Agenda
City Plan Commission Meeting
Municipal Building, 625 52nd Street – Room 202, Kenosha, WI
Thursday, April 18, 2024
5:00 pm

CITY PLAN COMMISSION
Minutes
April 4, 2024

City Plan Review Comments November 3, 2023
Site Plan - Addition
 kuenyarch.com ©2024 Kueny Architects L.L.C. - All Rights Reserved
 St. Vincent de Paul - Addition & Main Entrance Remodel
 7531 30th Ave, Kenosha, WI 53142
 February 20, 2024

C-3
 SHEET

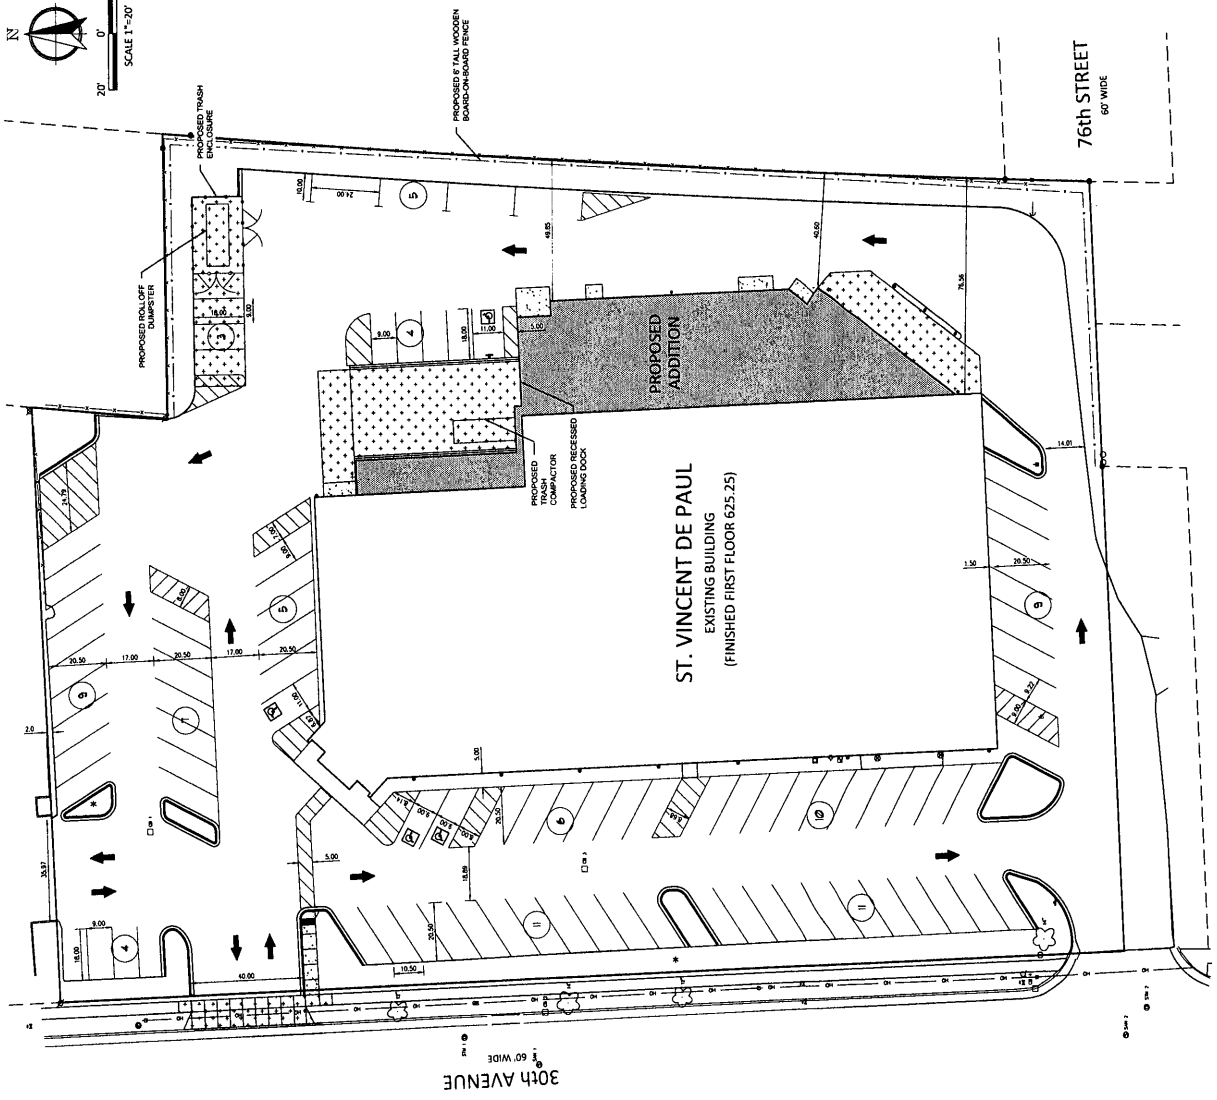
- i. Site Plan A102 and Sheet C-3 differ in the amount of off-street parking spaces, specifically in the northeast corner of the parcel. Both plans must be corrected to be consistent with one another.

Site Plan A102 and Sheet C-3 differ in the amount of off-street parking spaces, specifically in the northeast corner of the parcel. Both plans must be corrected to be consistent with one another.

There appears to be a discrepancy between the area measurements shown on Sheets A101, A102, and C-3. Please clarify the correct site data, area calculations and measurements.

- 1.1 See stormwater management plan for proposed extent of "disturbance".**
- 1.2 pavement reconstruction is proposed east and south of the building.**
- Total disturbance is 0.97 acres.**
- 2.0 See sheets C-6 and C-7 of the attached Civil Plans**
- 3.0 Title sheet for the new site calculation on Site Plan A102 was corrected.**
- Site data on sheet C-3 has also been updated.**

1 Site Plan - Addition
1" = 20'-0"

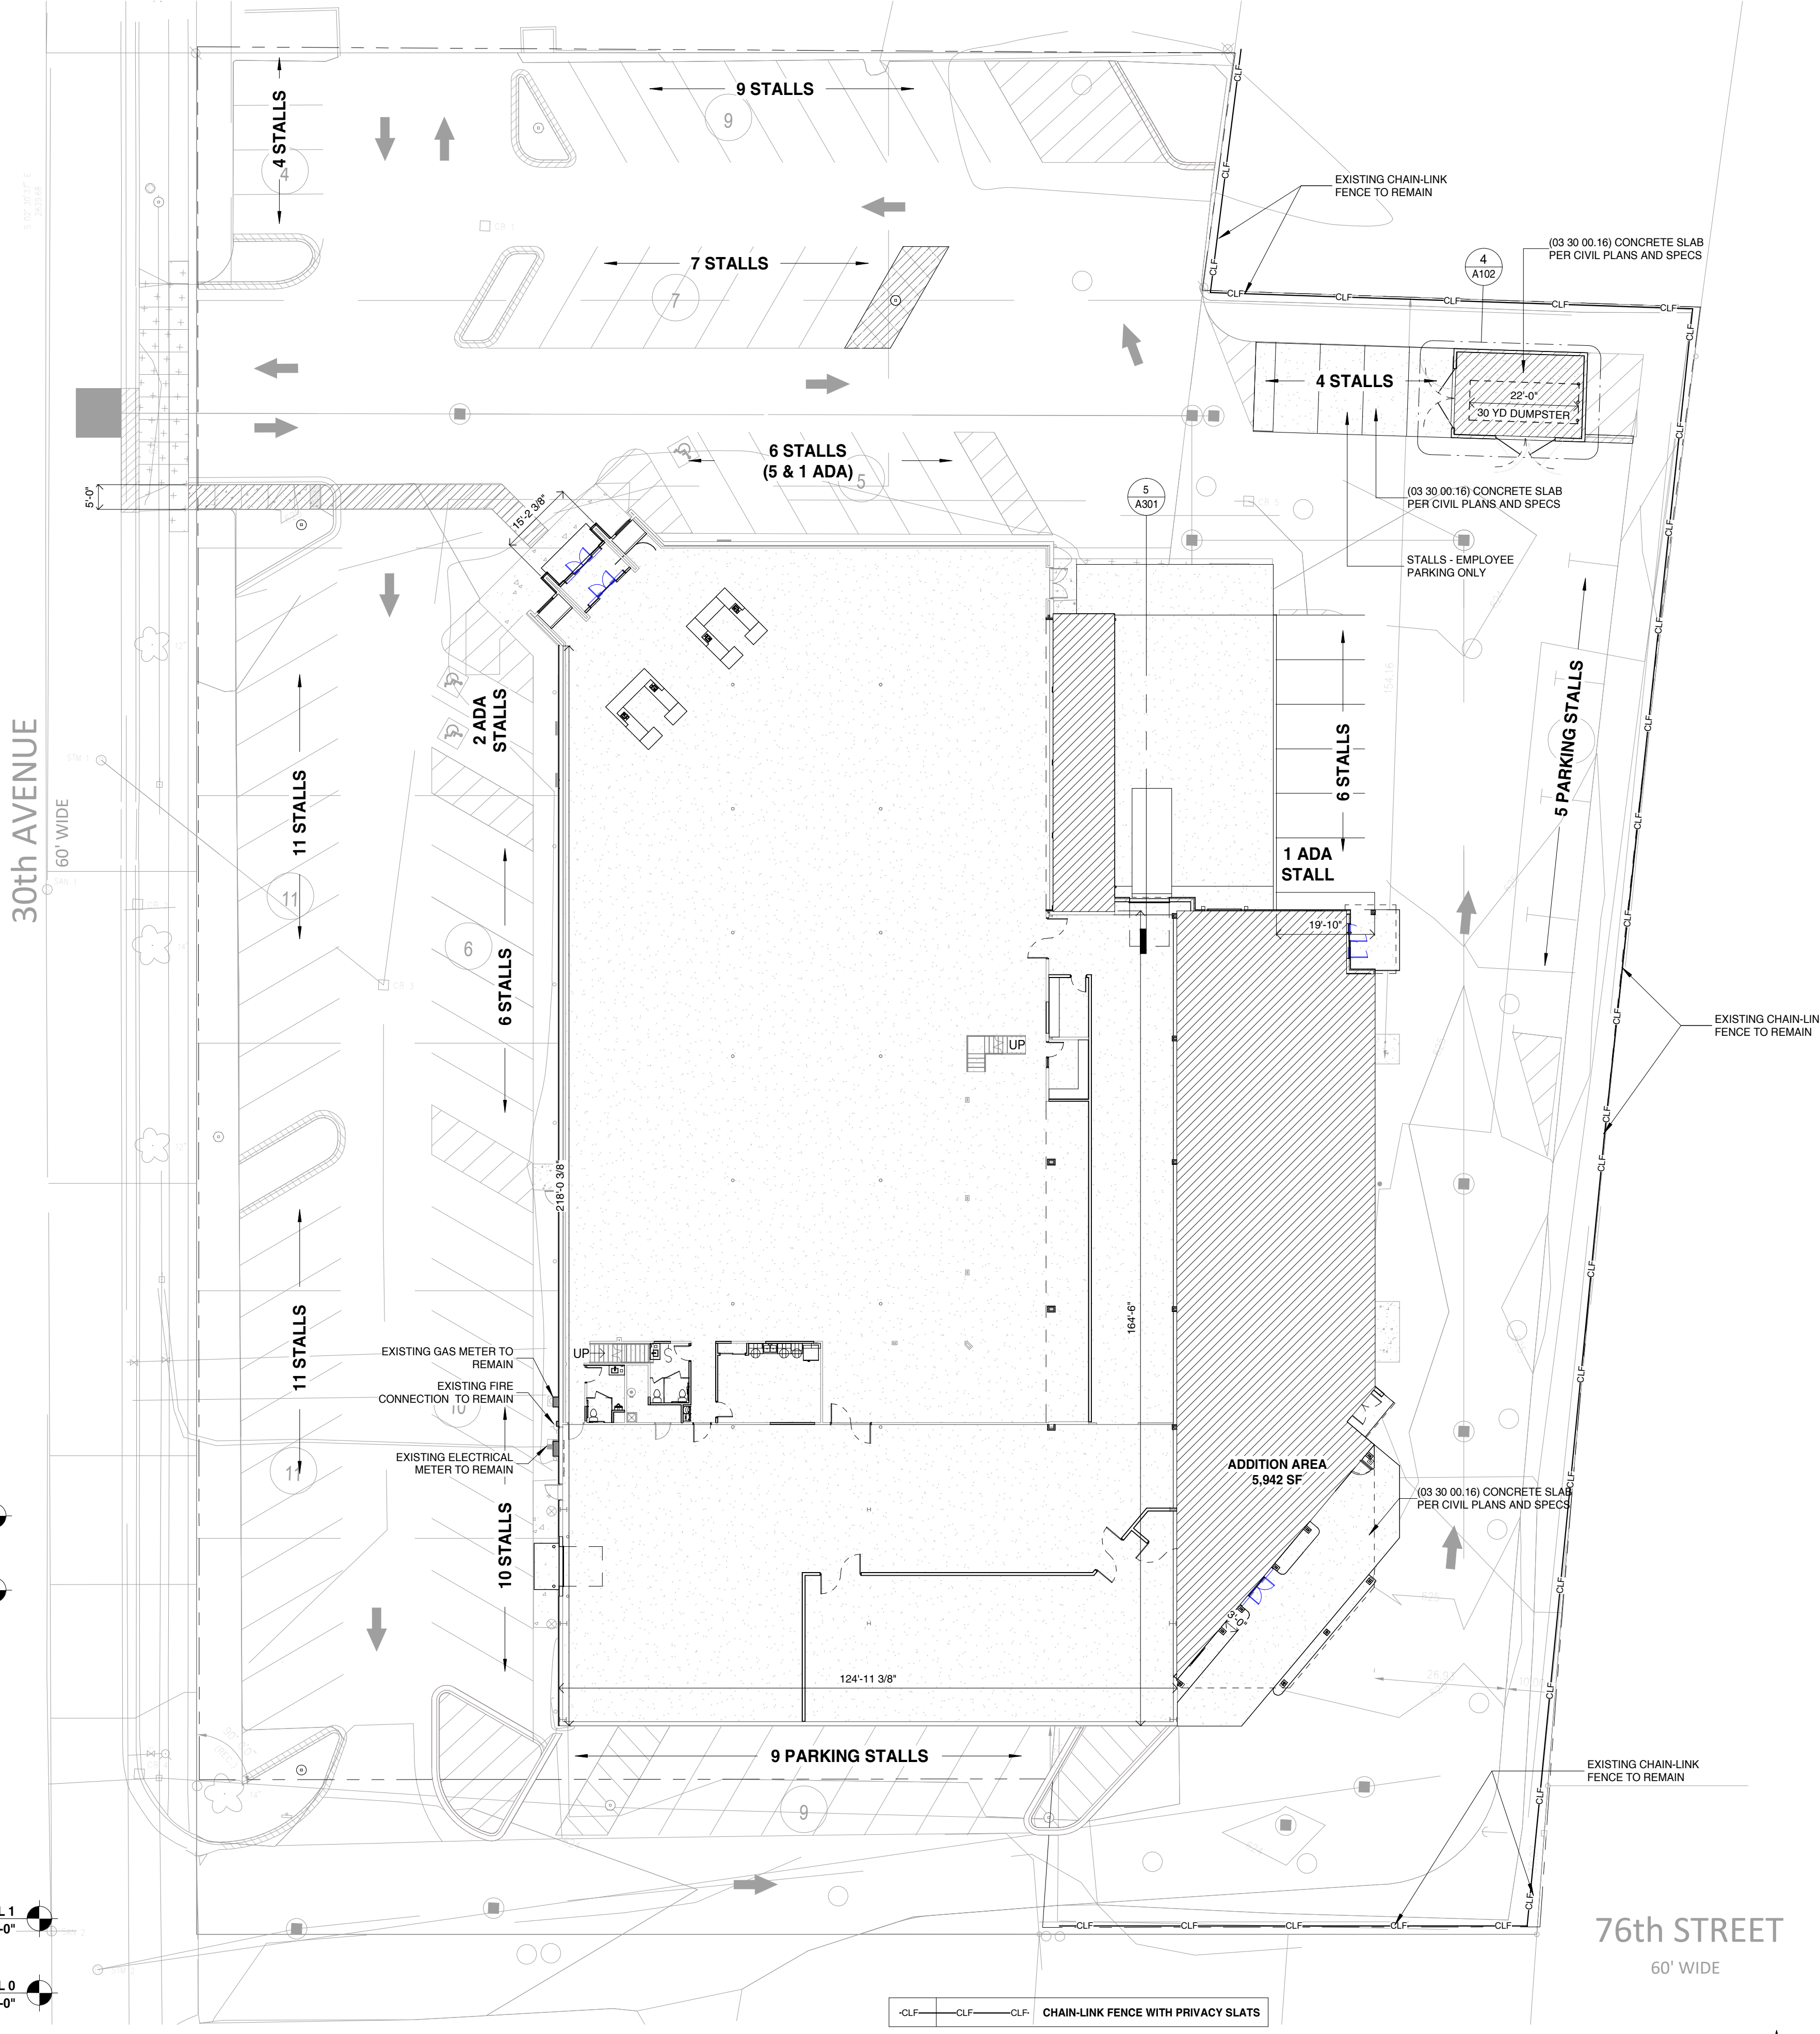
Show on the plans if there is a 6' tall screen fence along the east property line abutting the residential uses. Anywhere there isn't a 6' tall screen fence on your property or a neighbor's fence will need to show that a 6' tall screen fence will be installed.

The Site Plan must show that the west property will include a six-foot tall solid screen fence along any residential rear yard that does not currently have a solid screen fence. All barbed-wire must be removed from the existing fence.

he existing 6 ft chain link fence against the residential properties are shown in the civil plans and also on sheets A101 Site Plan – Existing, A102 Site Plan – Addition, and A103 Landscape Plan.
